INSTRUCTIONS FOR UPDATING YOUR ER

BRAIDWOOD NUCLEAR GENERATING STATION - UNITS 1 & 2
ENVIRONMENTAL REPORT - OPERATING LICENSE STAGE

VOLUNTARY REVISIONS

Amendment 6 consists of voluntary revisions to the following parts of the Braidwood Station Environmental Report - Operating License Stage:

FIGURE QE 240.5 - 1

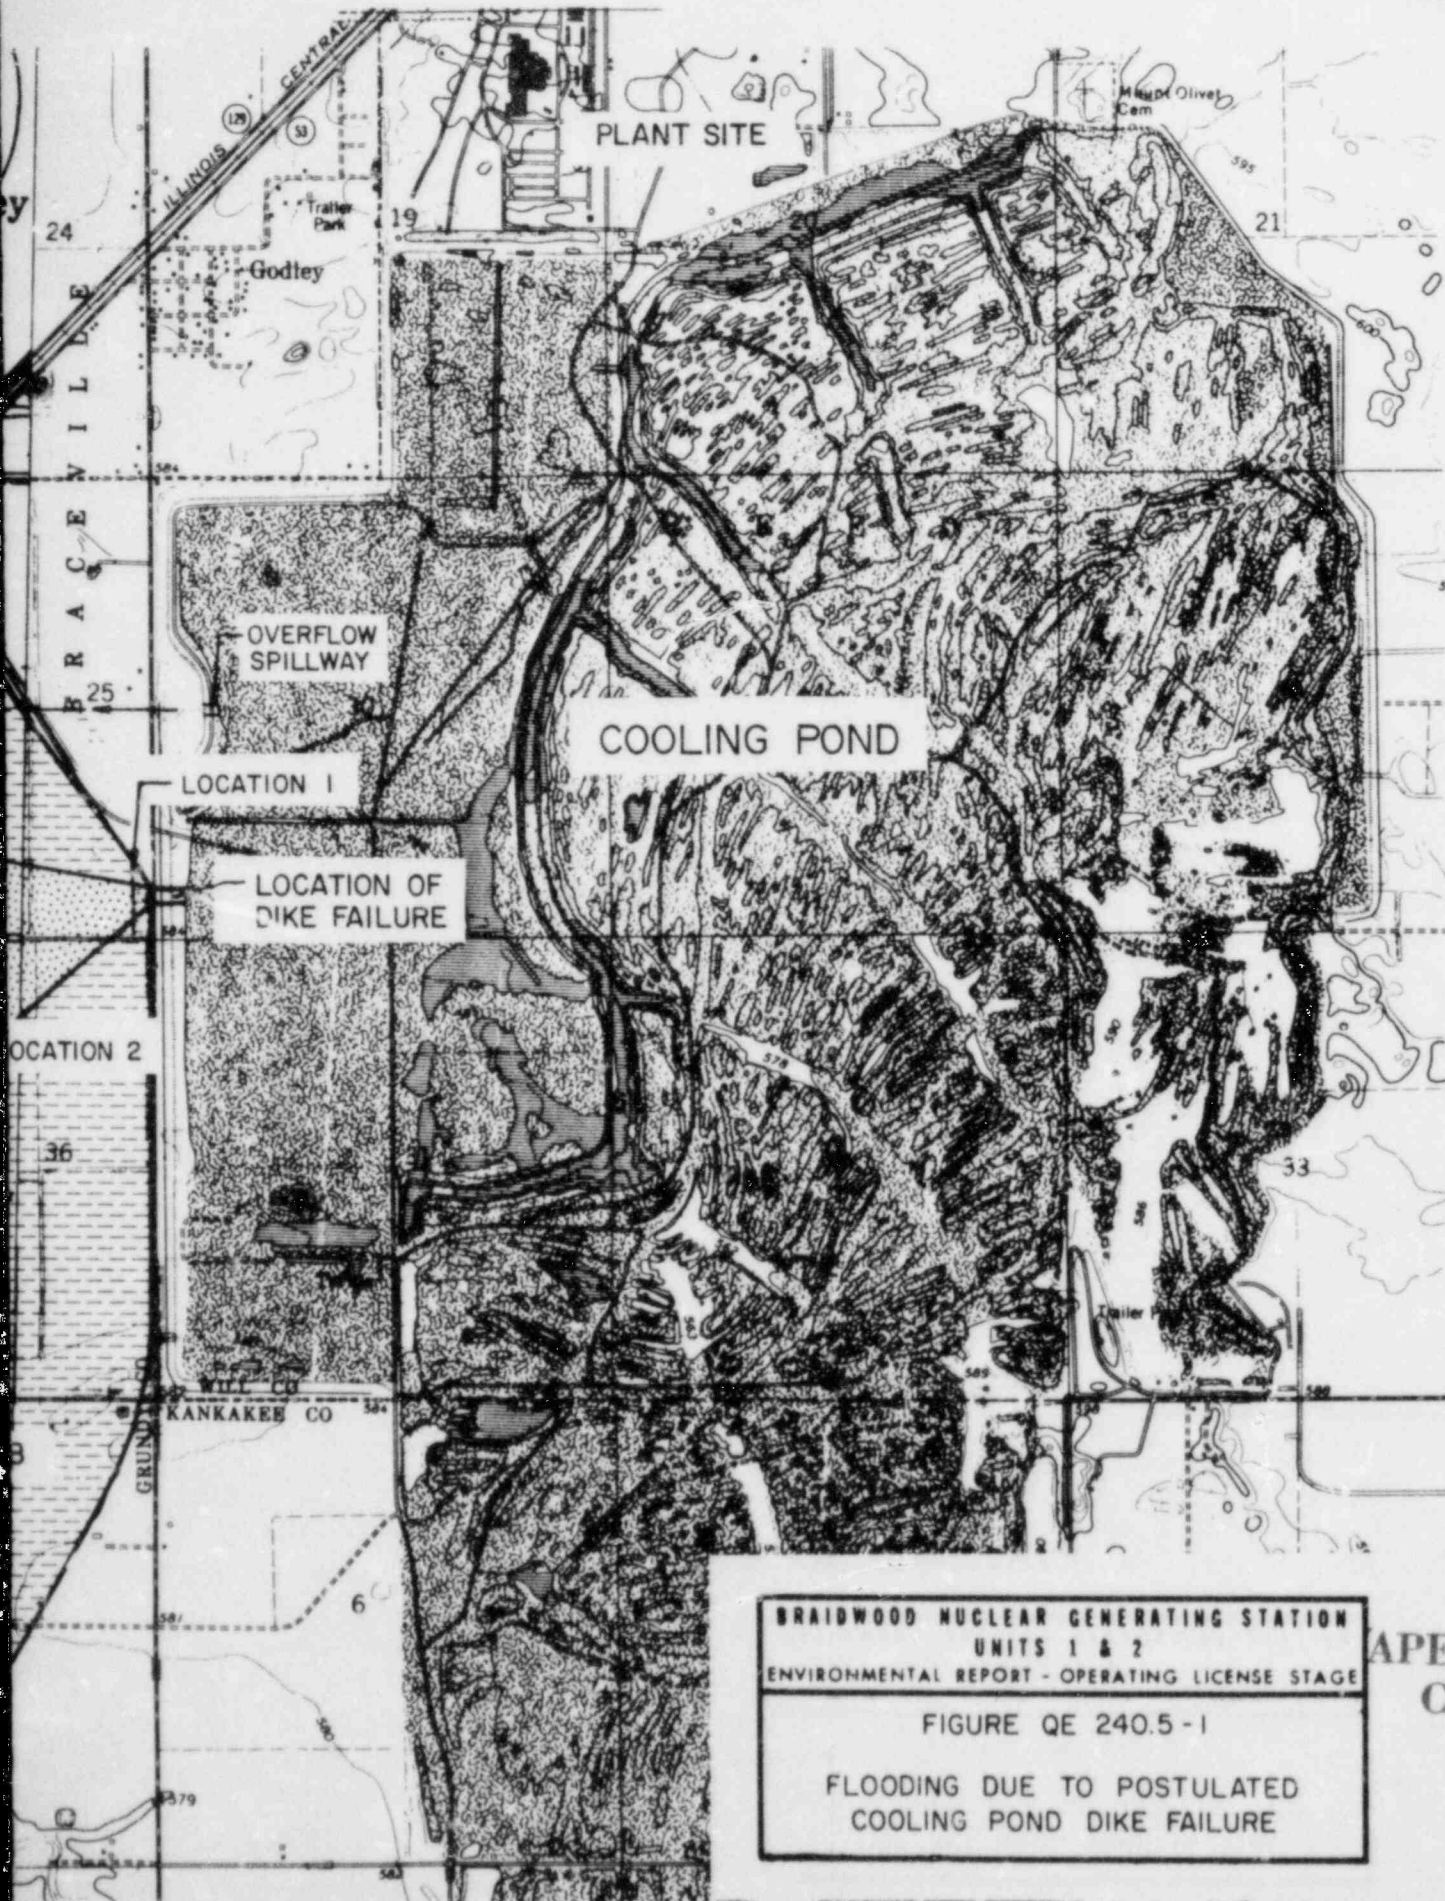
What are the potential impacts to local population and property of a postulated failure of the dike that forms the onsite pond?

The area downstream of the west dike is farmland and slopes down in a westerly direction towards the Mazon River. The outflow through the postulated breach will spread out and flow as shallow overland flow to the the Mazon River (Figure QE240.5-1). Based on the topography and the slope of the area west of the dike failure section, the area was divided into i) a primary flow zone (Zone A) and ii) a backwater zone (Zone B), as shown in Figure QE240.5-1. The primary flow zone would carry the outflow from the dike failure and the backwater zone will form due to the water spreading laterally from the primary flow zone. Three locations were selected in Zone A, where the flow depths and velocities are estimated for outflows from the breach at different times after the dike failure (Table QE240.5-1). The depths and velocities of flow at a given location were estimated based on the slope of the area west of the dike and the width of primary flow zone at that location.

It can be seen from Figure QE240.5-1 that the community of Braceville would not be affected directly by the primary flow from the dike failure, however, the backwater zone would extend to parts of the community.

The community of Braceville lies west of the cooling pond; however, it will not be significantly affected by a dike breach since most of the town is north of the path of the outflow from the breach. In addition, the community will be protected by the embankment of Routes 53 and 129 and the Illinois Central Gulf Railroad. There is a small portion of Braceville, consisting of approximately 31 homes, located south of the railroad tracks and 11 farmsteads with homes, some with farm related structures which would be in the impact area. Of the Braceville homes only 7 are in the primary flow zone as are 7 of the farmsteads. The total population of the homes in the impact area is approximately 119, 39 of which are in the primary zone.

Therefore, the postulated dike breach would flood some farmland west of the cooling pond but will have very little impact on the population near the cooling pond.
